**Jodhpur Pollution Control And Research Foundation**

Ref. No. JPCRf/mem/60/2026/140Date 4/07/2026**Corrigendum-1**

Reply of quarries raised by the various companies were considered and were properly address/ replied as given in table given below. This reply is part of the original tender as corrigendum and bidders are advised to consider the reply and bid accordingly.

Lay out of Plant:

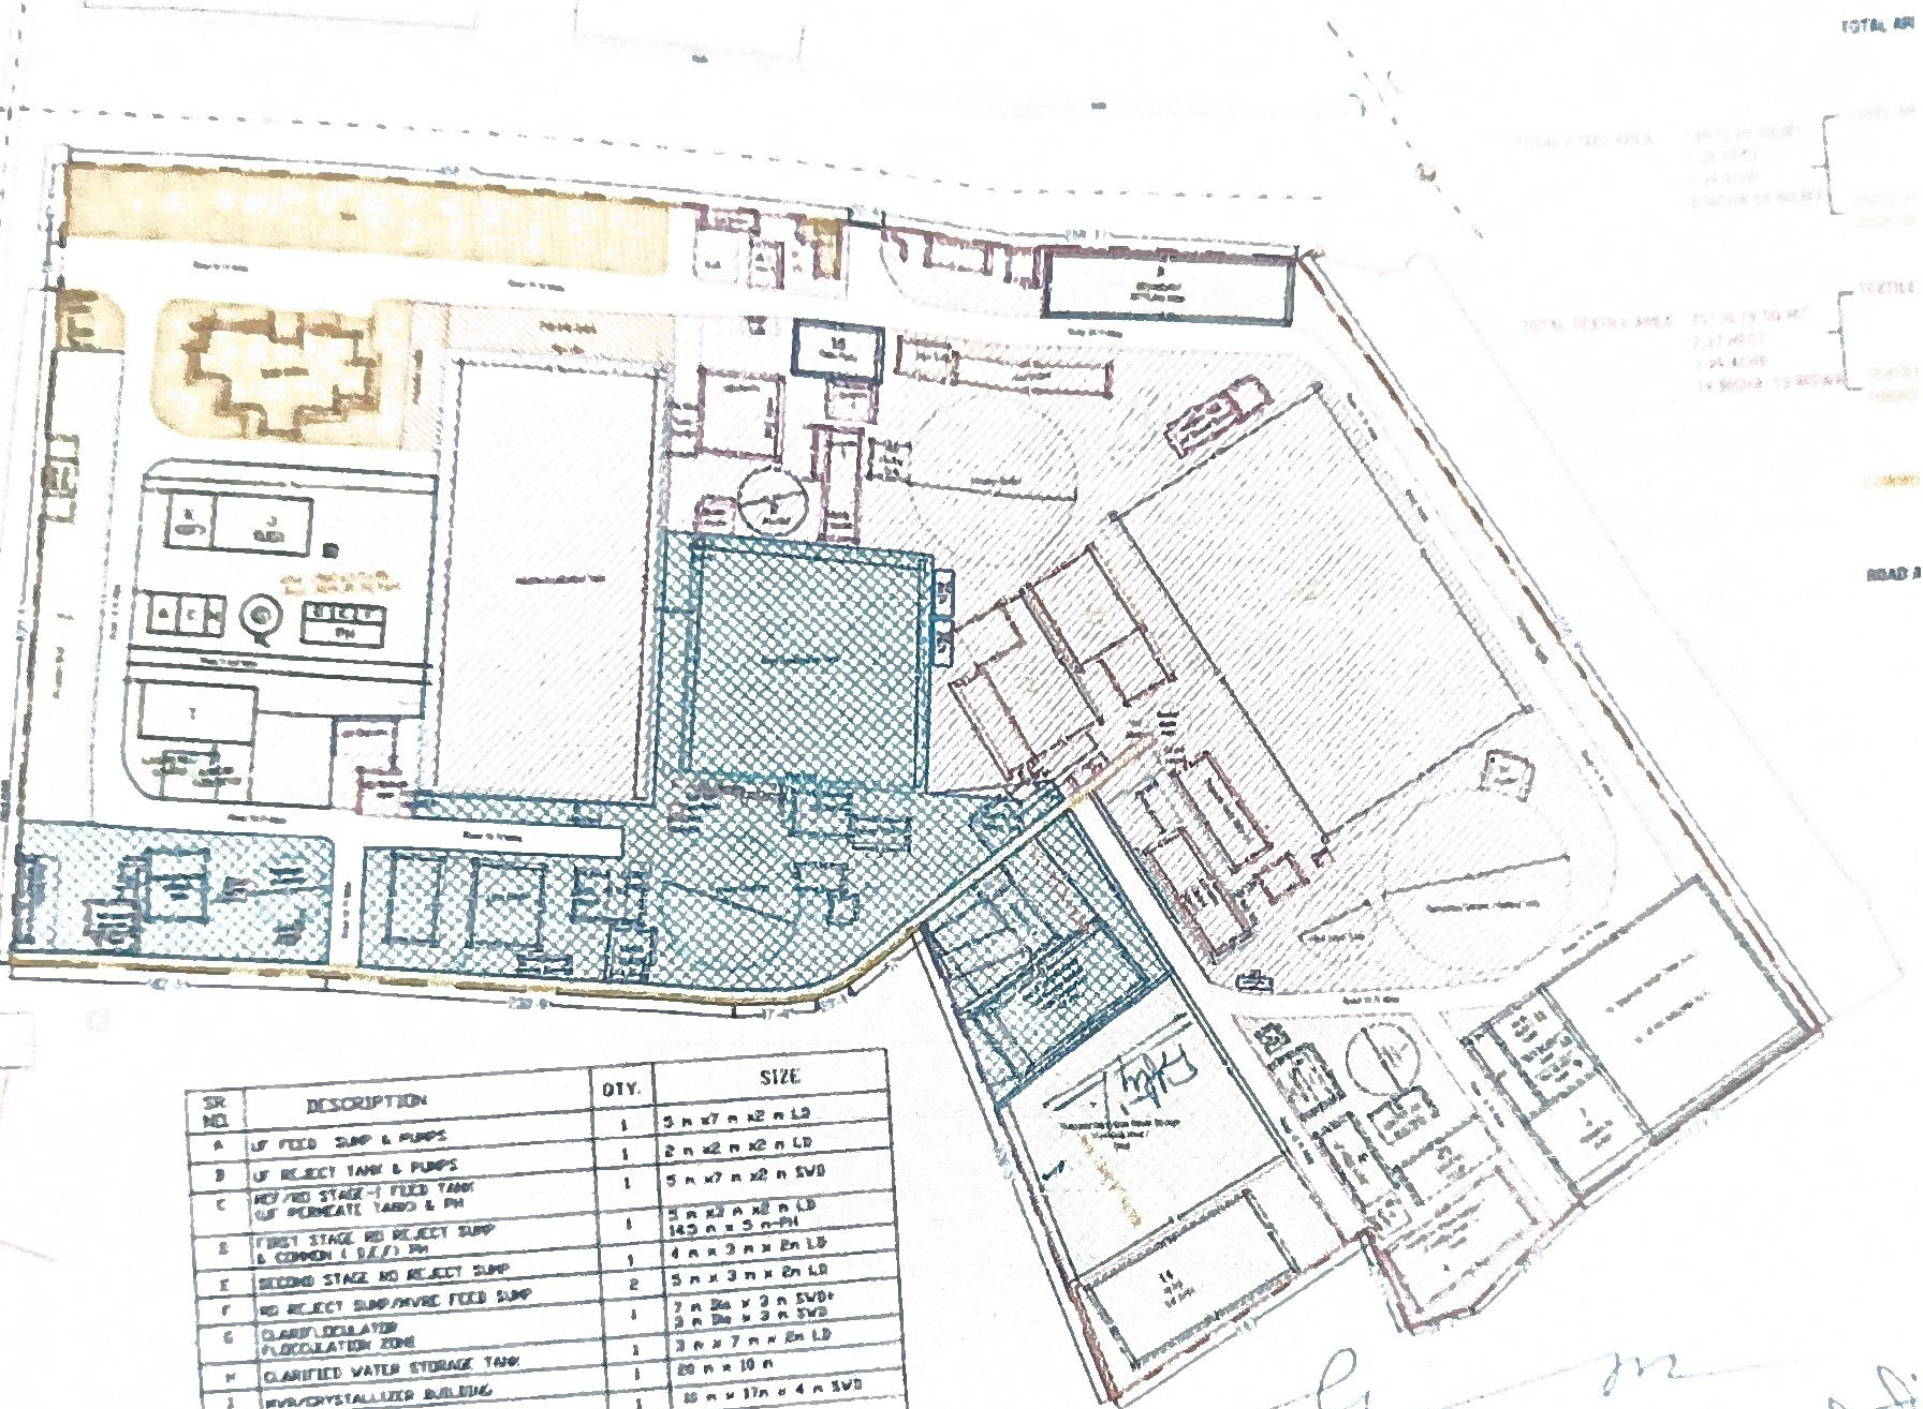
M/s Advent Envirocare	Sr. No.	Title	Page No.	Clause No.	Description	Tender Requirement	Queries	Reply by JPCR
	1	Part -A: Technical Proposal and existing details	-	-	-		Kindly provide the following drawings of the existing plant: 1. Layout in autocad with dimensions. 2. GA drawings of all units 3. Vessels GA drawings 4. Hydraulic Flow Diagram of the existing plant	General layout is given at the end of the reply of queries. The bidder may visit the site before bidding. Most of the work is related to electro mechanical except DAF and sludge management. The sizes of the units are given in the technical proposal.
	2	Part -A: Technical Proposal and existing details	A) 13 of 227 B) 32 & 33 of 227	A) 3.2.10 B) 5.5.1	A) PSF & ACF B) 5.5.1 Glass Media filter (GMF) / AFM Filter & Activated Charcol Carbon (Modify existing PSF & ACF)	A) The treated effluent from the clarifier treated water tank is further pumped to 10 nos. of Pressure Sand Filter for filtration of water. Filtered water is further treated in 10 nos. of Activated Carbon Filter to remove traces of colour and other contaminant is present	Please clarify whether the total quantity of PSF & ACF units is 9 Nos. or 10 Nos. Both tables regarding the size of PSF and ACF appear contradictory. Kindly clarify this discrepancy in the specified sizes for all quantities of PSF & ACF.	Read as given below in place of dimensions mentioned in the technical proposal (if at any place it differs) Total No. of PSF = 9 Nos. 5 Nos. = 3 m Dia. x 2.2 m ht 4 Nos. = 3.4 m Dia. x 1.8 m ht.
